District Office- Tenant Improvement

981 Ridder Park Drive, San Jose, CA 95131
MDG Project # 2203

MECHANICAL UPGRADES – BID #B-03-2022-23
ELECTRICAL UPGRADES – BID #B-04-2022-23
GENERAL CONSTRUCTION – BID #B-05-2022-23

October 21, 2022

PLUMBING PLAN

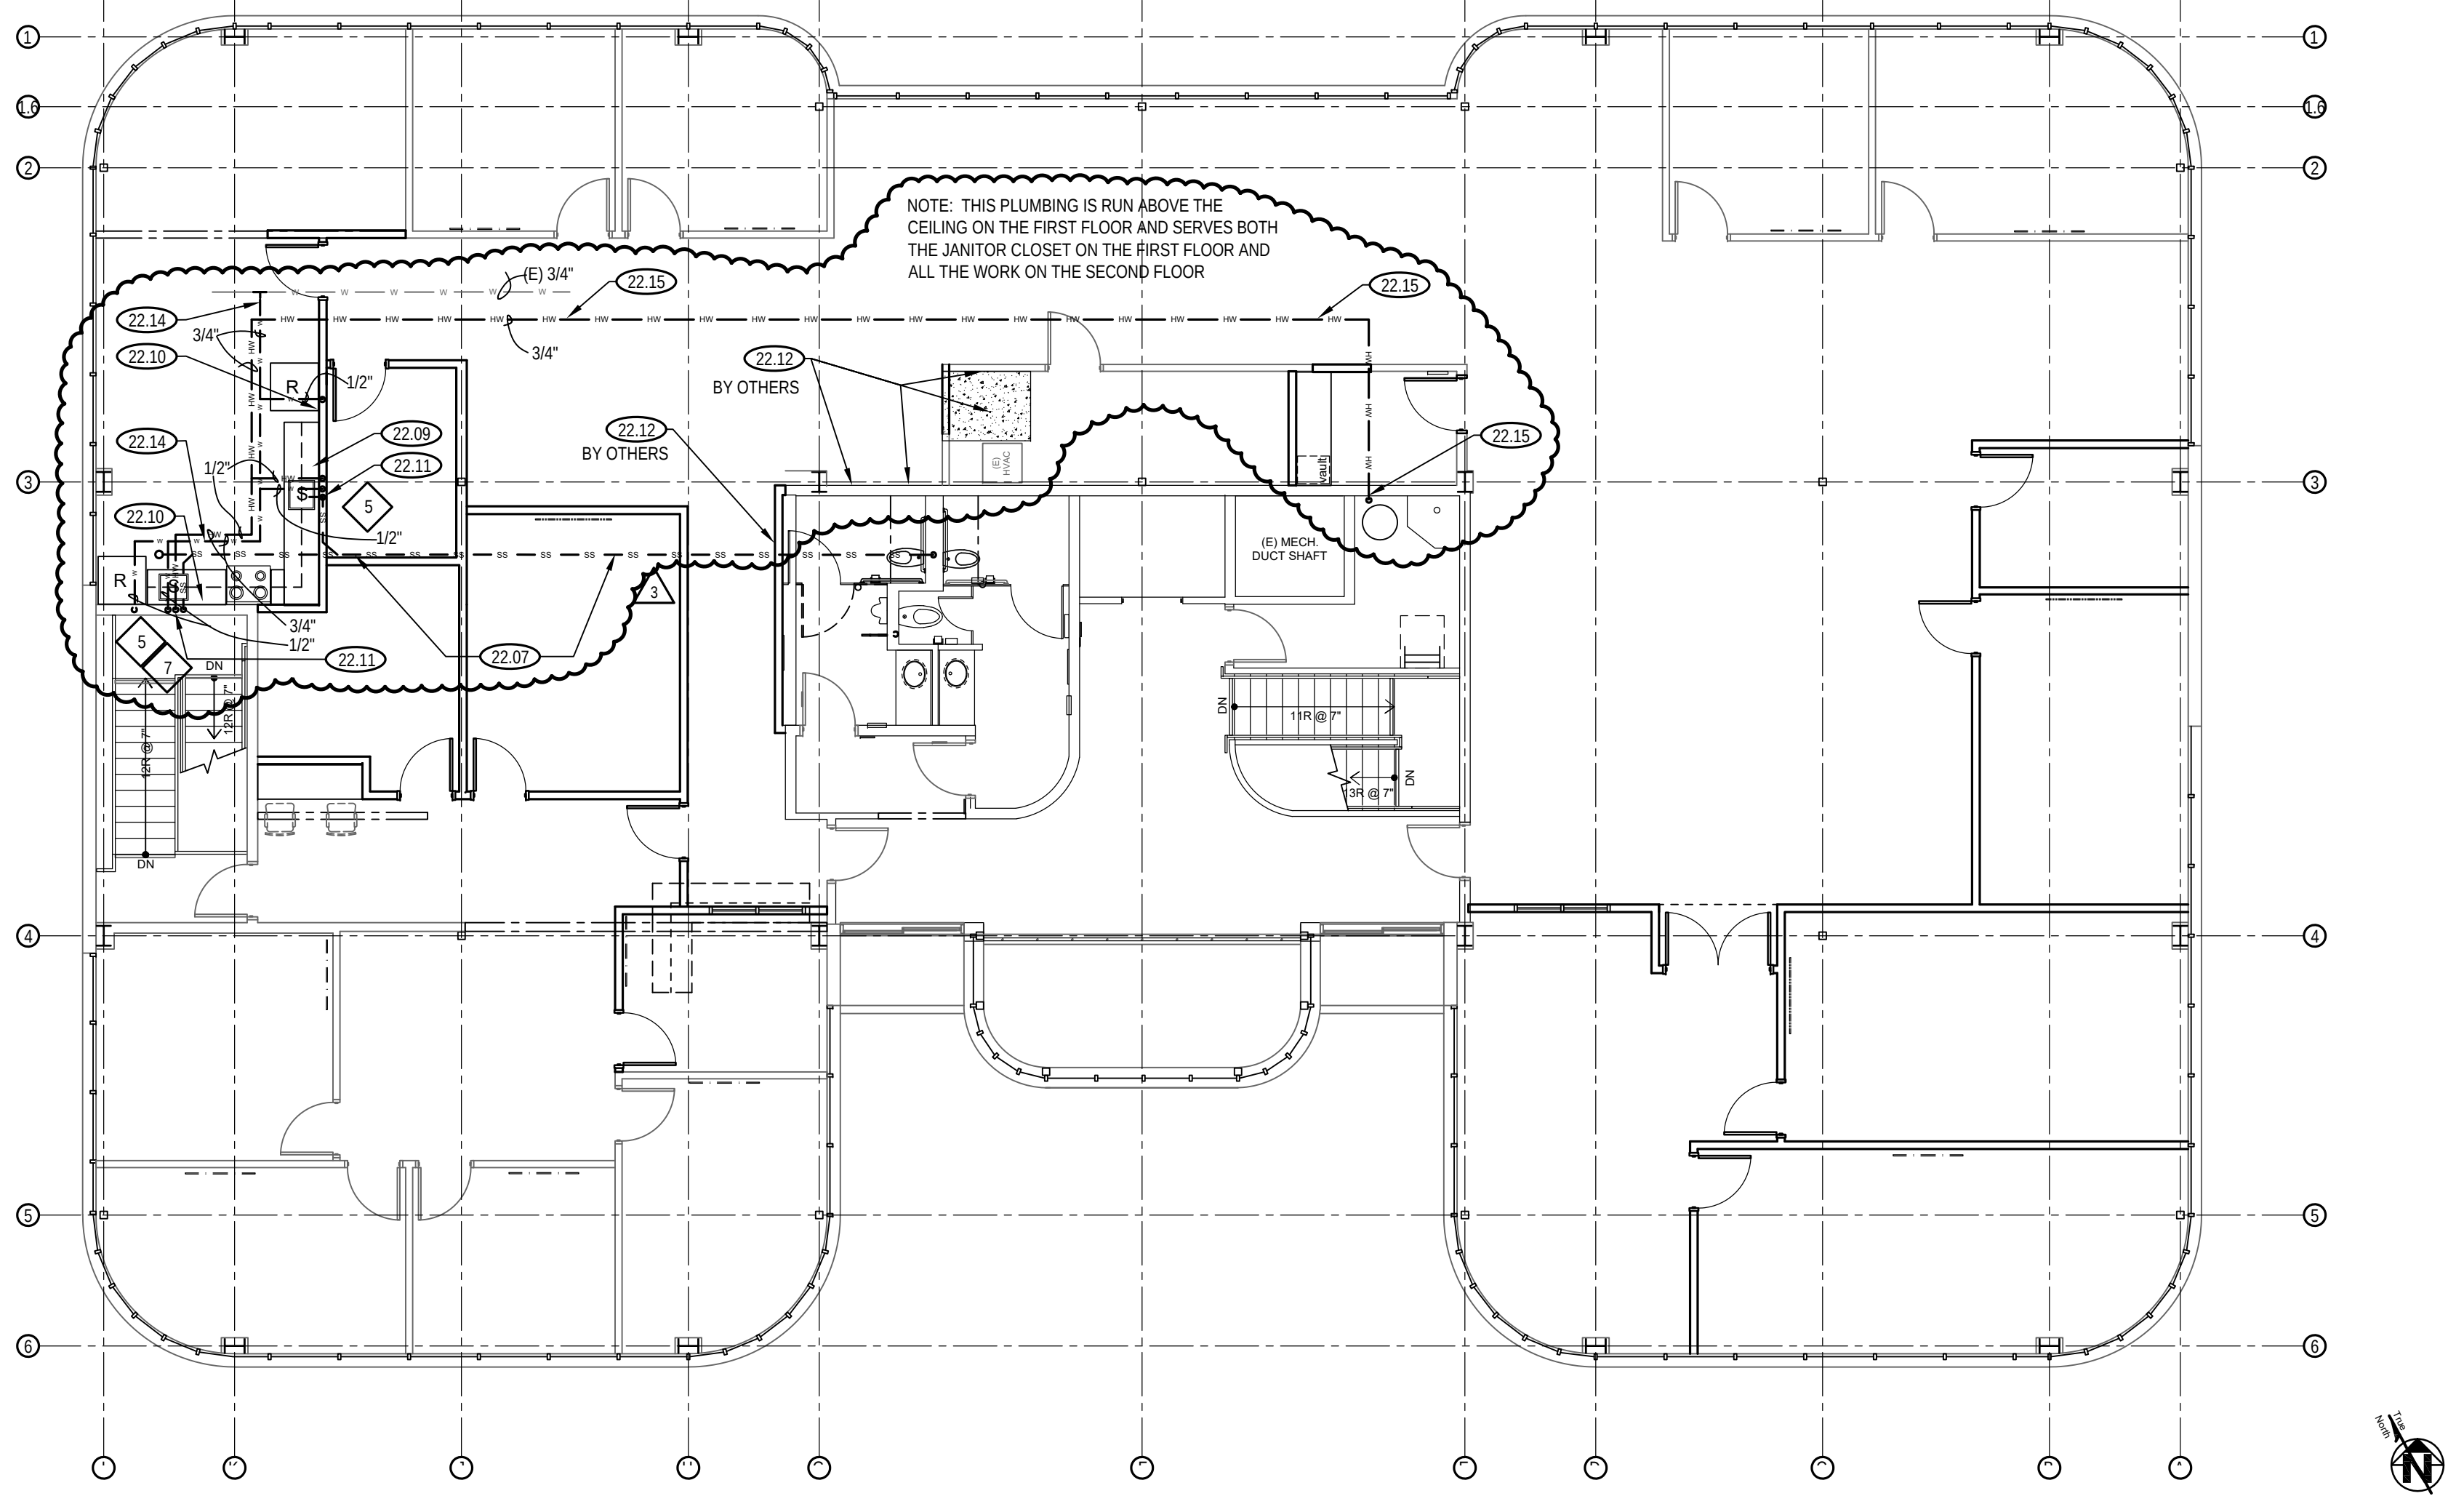
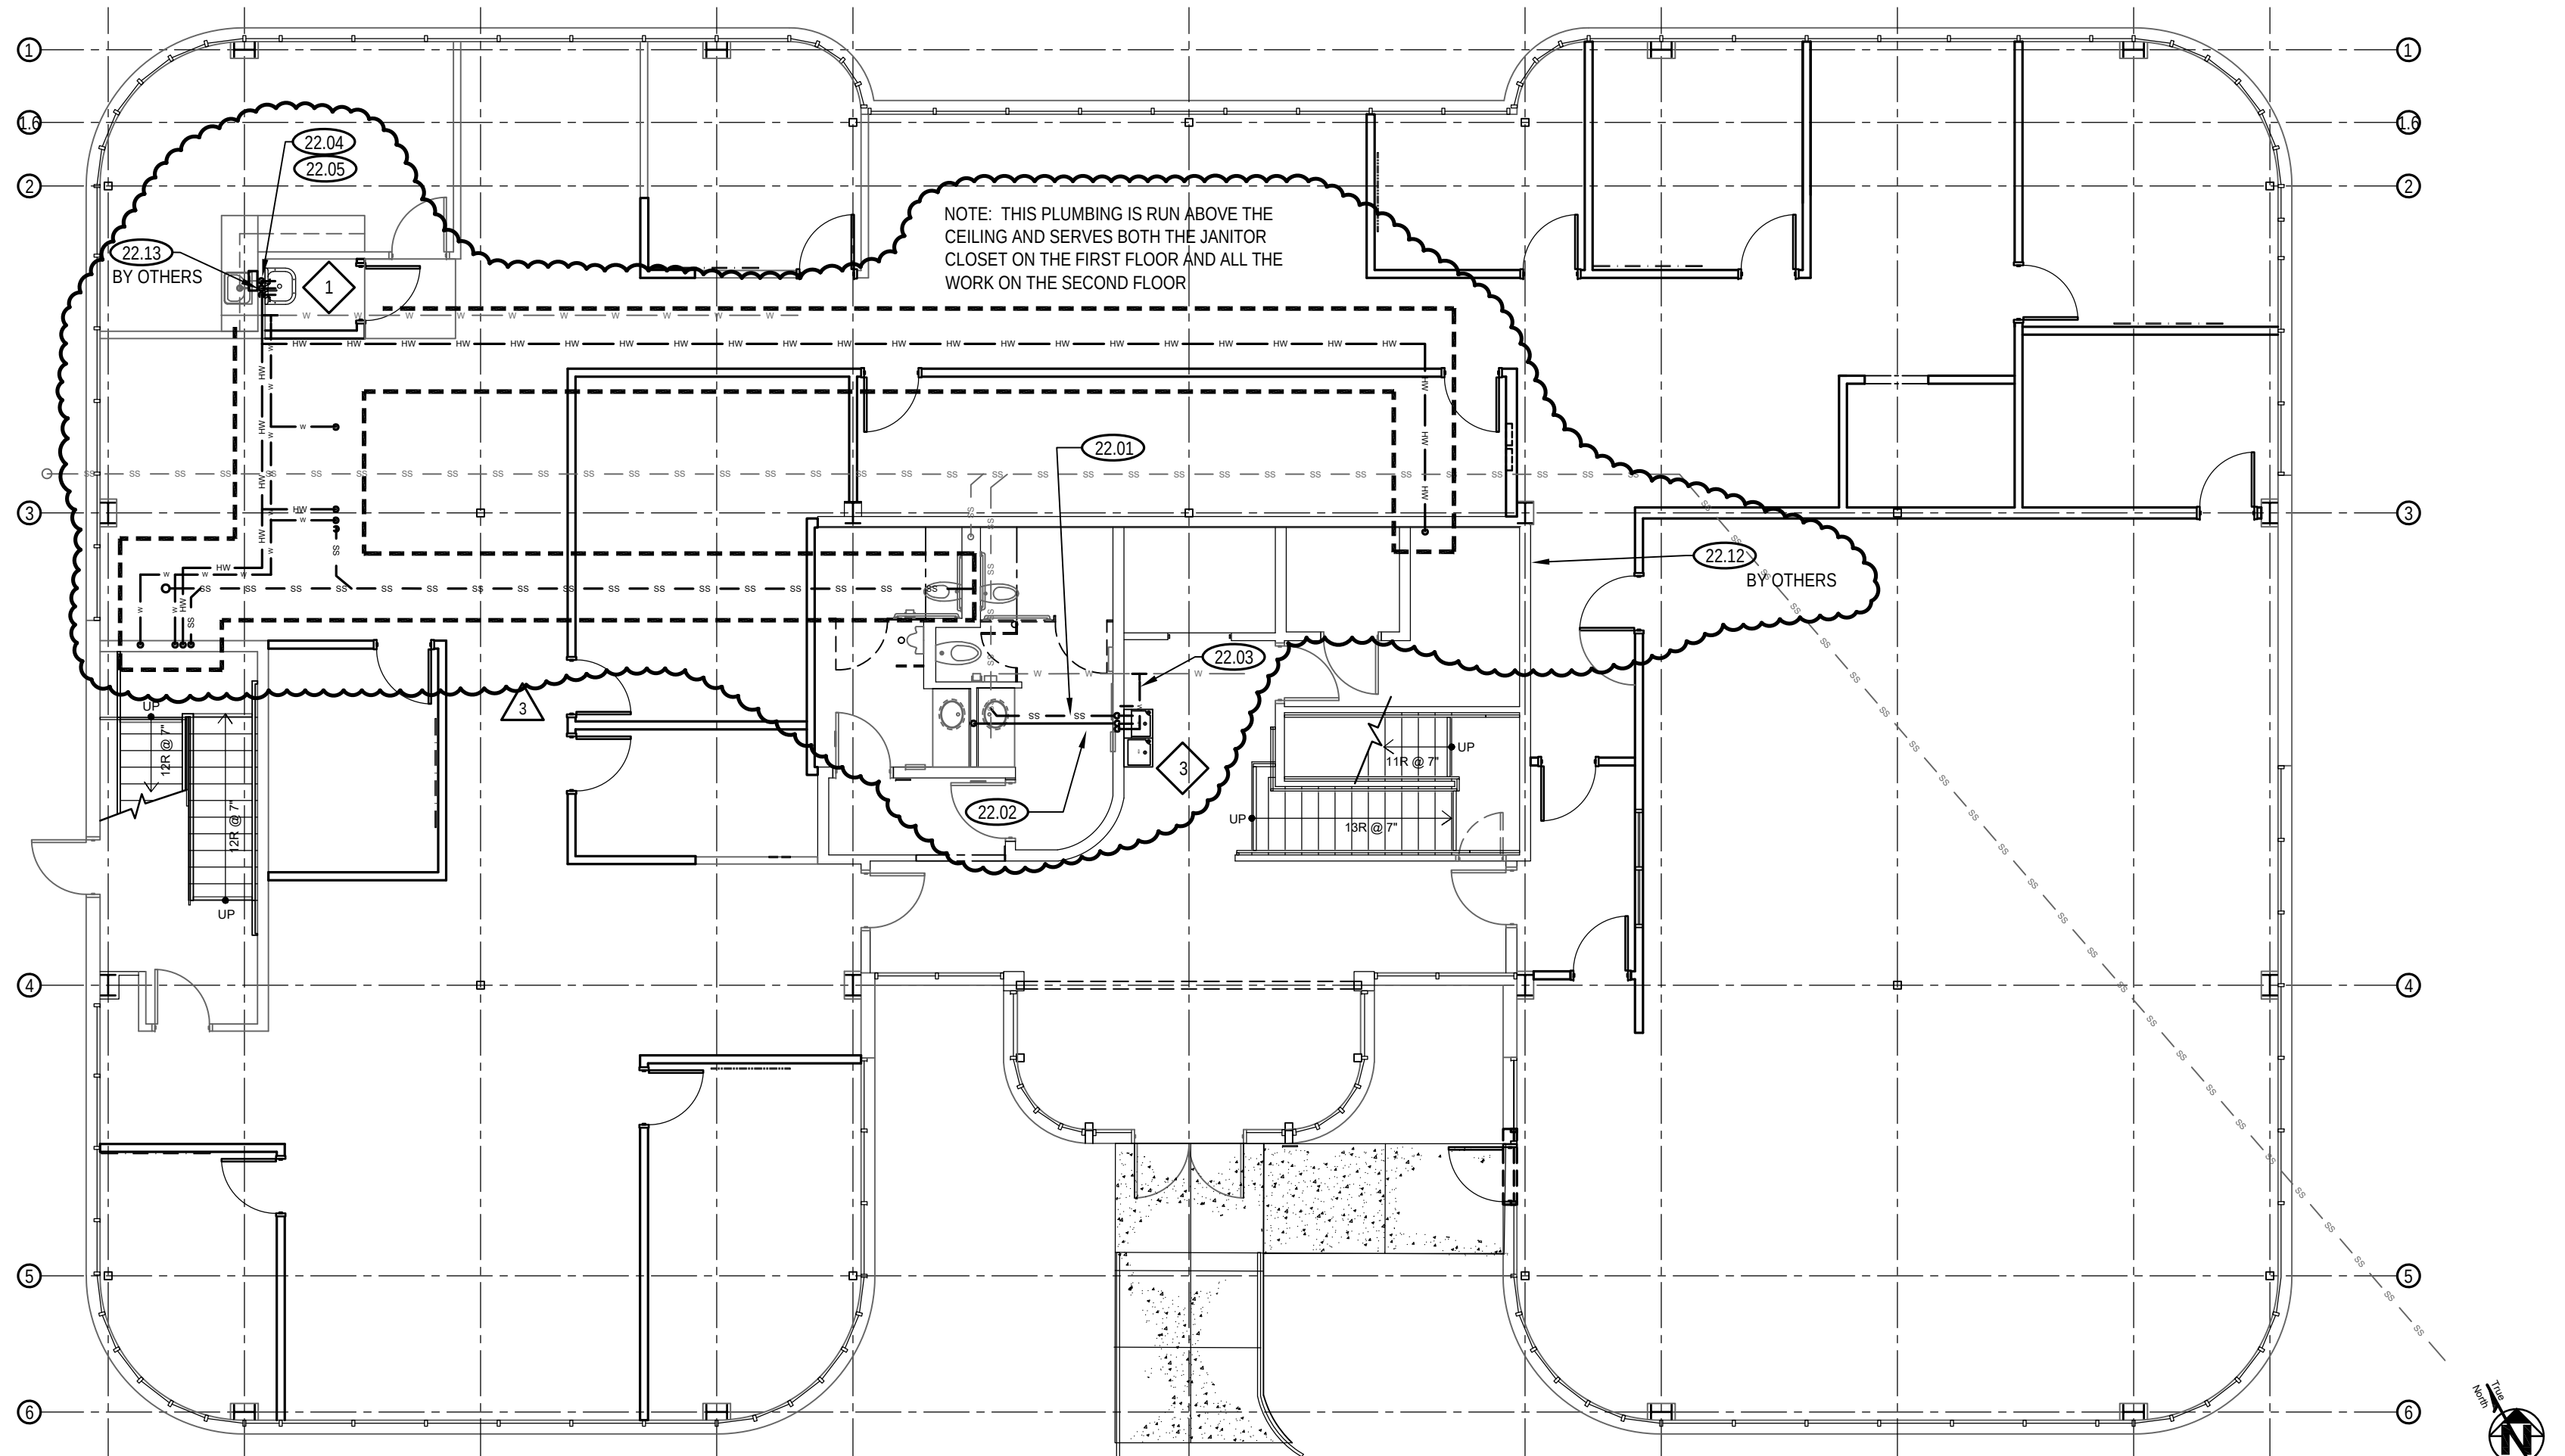
Item #15: Sheet P-1.0 Plumbing Plan

- A. First Floor Revisions:
 - a. Drinking Fountain – Removed the sanitary pump and are now trenching and providing an underground sewer connection inside the adjacent Restroom. Contractor will need to locate the (E) underground sewer line and connect to it.
 - b. Janitor Closet – Removed the water heater and are now connecting to the existing water heater in the upstairs Janitor Room.
 - c. Break Room – Added to reconnect the existing insta-hot water heater under the existing sink.

- d. Showed the plumbing work that is to be provided above the ceiling for the second floor plumbing items.
- B. Second Floor Revisions
 - a. Break Room – Added an additional sink and also a garbage disposal.
 - b. Break Room – Removed the new water heater from the scope
 - c. Water and Sewer – Changed the routing for all water and sewer including connecting to the existing water heater in the upstairs Janitor Room.
